INITIAL FIRE SAFETY INSPECTION REPORT

The Rose Dresses Ltd. & Islam Garments Ltd. & Islam Dresses Ltd. (Extension)

RSC ID: 26037

Inspected By: Md. Ferdaus Jaman
Date: 17-March-2025

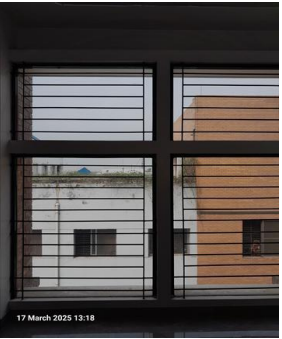
SI No.	Category	Findings	Required Action	Remediation Time Frame
F-01	Means of Egress	Building-10 (Rose Tower): The exit stair enclosures are not separated from work areas and other spaces on each floor by fire-rated construction.	The exit stair enclosure shall be provided with a minimum 1-hr fire resistance rating for buildings with 3 or fewer stories and a minimum of 2- hr. fire resistance rating for buildings 4 or more stories. Provide 1-hr. fire rated door and seal all penetrations and openings by 1 hr. fire rated fire rated barrier construction for building with 3 or fewer stories. Provide 1.5 hr. fire rated door and seal all penetrations and openings by 2 hr. fire rated fire rated barrier construction for building with 4 or more stories in accordance with section 6.3.1.2 of RSC Technical Guidelines (Standard)¹ V1.0. Ensure that the fire doors are self-closing and positive latching and that they are provided with fire exit (panic) hardware where serving production floors. If fire doors are required to be held open for functional reasons, provide automatic closing devices tied to the fire alarm system. Every door in a stair enclosure serving more than 5 stories shall be provided with re-entry unless it meets RSC Technical Guidelines (Standard)¹ V1.0. Section 6.8.3.1.	Within 3 months
